## Garrett Park Road Bridge over Rock Creek, Mandatory Referral, MR2021004

Construction of a replacement bridge on Garrett Park Road in North Bethesda, Maryland. The project elements are a 66-foot-wide bridge along Garrett Park Road across Rock Creek to the west of Beach Drive, and the construction of a temporary bicycle/pedestrian bridge on the north side of the existing bridge during construction.

### Staff Recommendation: Approval to Transmit Comments

Figure 8: Proposed Temporary Pedestrian/Bicycle Bridge and Sidepath Connections

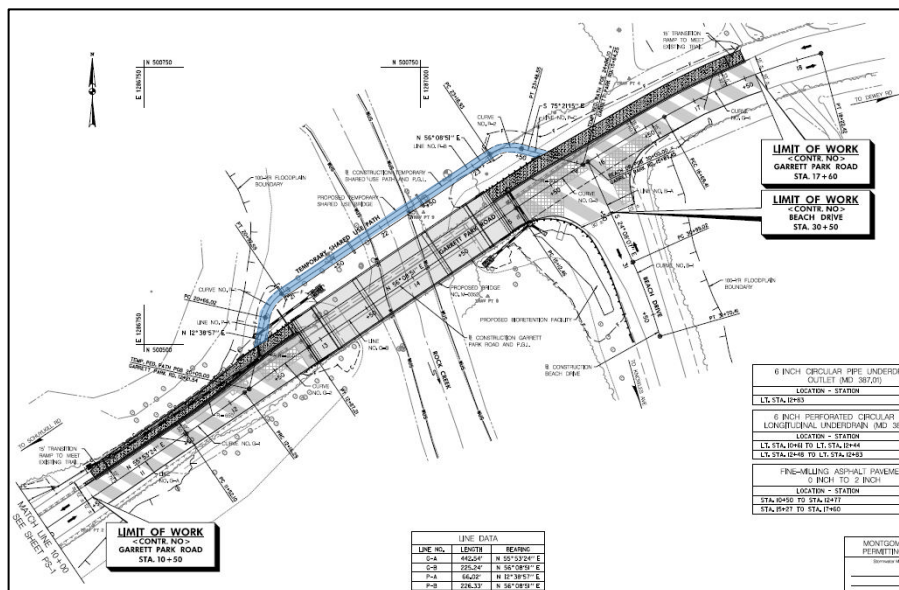
The project design includes the construction of a temporary pedestrian/bicycle bridge on the north side of the existing structure allow pedestrian and bicycle traffic to continue during the proposed summer construction schedule. The alignment of the temporary bridge is shown below in Figure 8 in blue shading.

The connections of the temporary sidepath into the improved sidepath along Garrett Park Road does not meet current or developing AASHTO Bike Design standards, and will result in bikers either having to slow down significantly in order to make the turns or will result in bikers riding off the trail intersection to create their own path. While this will occur for only three months during construction, proper bike design would require a 40-foot-radius curve to accommodate bikes at a speed of 15 mph.

6. Adequate 6-foot-wide grass buffers should be provided between the proposed sidepath and proposed curb (on the non-bridge portions of the project).
7. The trail connections to the temporary sidepath bridge should be re-designed to accommodate bicycle travel at a travel speed of up to 15 mph using a 40-foot-radius curve. The transitions as planned are extremely abrupt.

Figure 9: Western End of Temporary Path and Connection onto Existing Sidepath

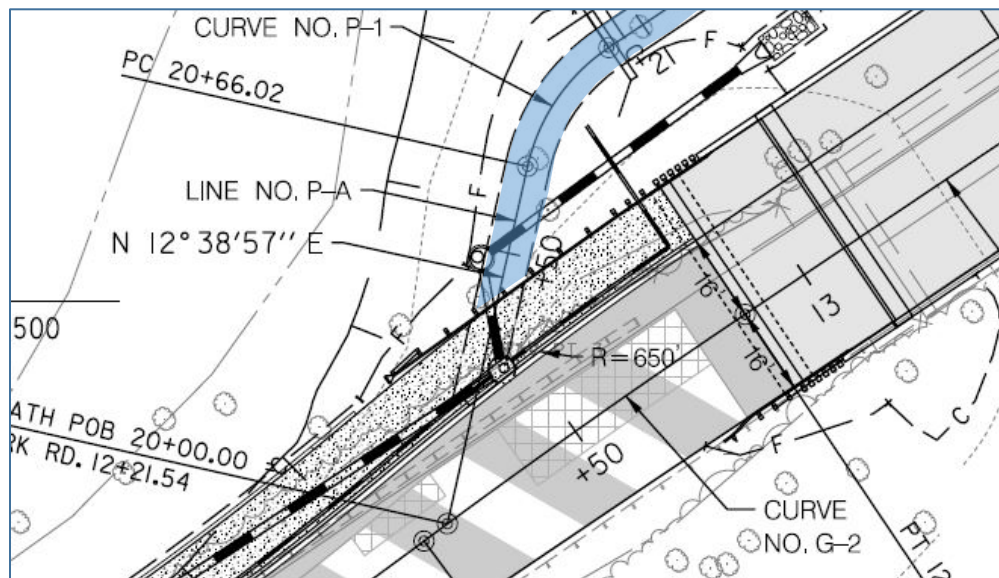
The connections of this temporary route into the existing sidepath is very tight with the temporary path terminating at the path at approximately a 135-degree angle. While usable by pedestrians, this transition will be difficult for bikers, except at very low travel speeds. Figure 9 shows the western end of the proposed trail and Figure 10 shows a photo of this approximate location.

Figure 13: Temporary Bridge Cross Section

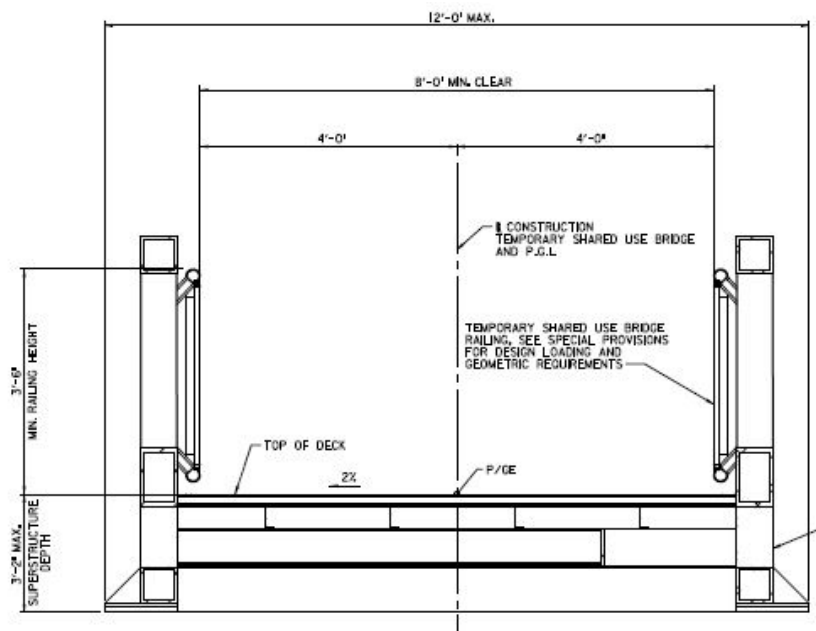
Figure 13 displays the proposed cross section of the temporary pedestrian and bicycle bridge structure. This bridge will have a clear width of 8 feet.

Figure 14: Proposed Typical Cross Section – Stations 10+61 to 11+58

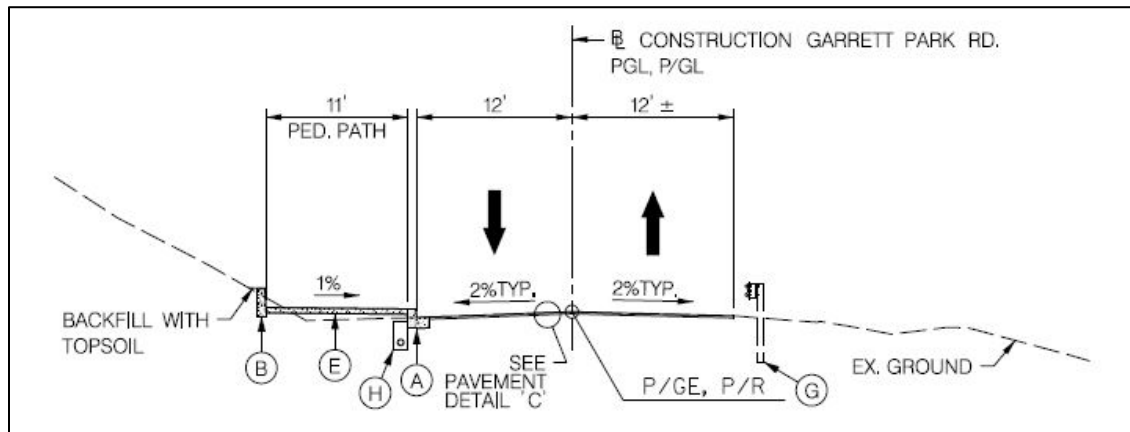
Figures 14 through 18 show the proposed typical cross sections on Garrett Park Road. Based on these cross sections, it appears that the existing guiderail now in place will be removed at the following locations:

- Bridge structure – the proposed 11'8"-wide sidepath does not provide the required minimum 8' clear width. Addition of 4" is needed.
- Sidepath – proposed sidepath will have no buffer between the 11-foot-wide sidepath and the curb. The addition of a 6-foot-wide buffer is needed to comply with the design guidelines in the Bicycle Master Plan and the Complete Streets Design Guidelines.

Figure 16: Proposed Typical Cross Section – Bridge Approaches

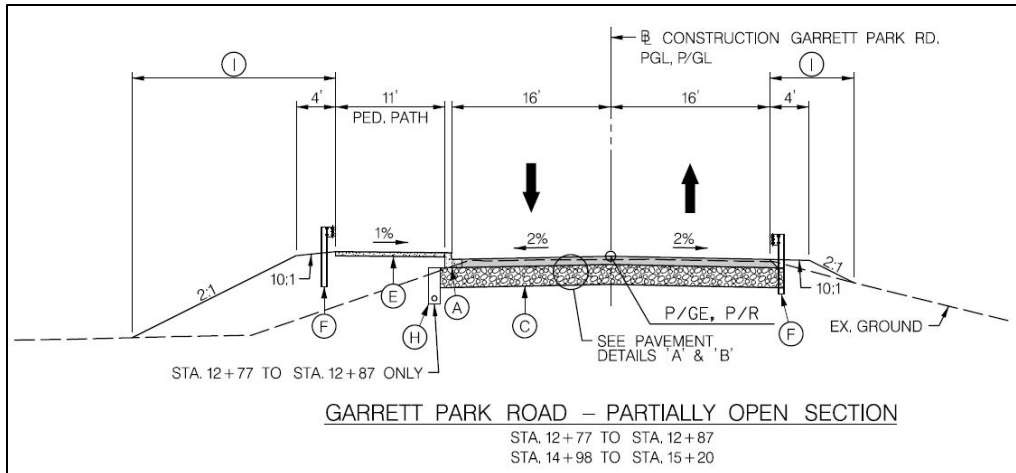
The proposed 46-foot-wide bridge will provide two 16-foot-wide travel lanes, a 11'8"-wide sidepath, and 3'-6"-high parapet bridge railings as shown below in Figure 5.

4. We would prefer the sidepath on the bridge to be made 4 inches wider to provide a 2-foot clearance from the parapet and a 2-foot clearance from the curb, leaving a minimum width of 8' clear. We think that this can be achieved without widening the bridge by shifting the curb.

5. Two 11-foot-wide travel lanes with 4'10"-wide shoulders should be provided on the proposed bridge (this includes the 4-inch reduction needed to shift the curb line). This will provide adequate space for vehicular traffic as well as bikeable shoulders on the structure.
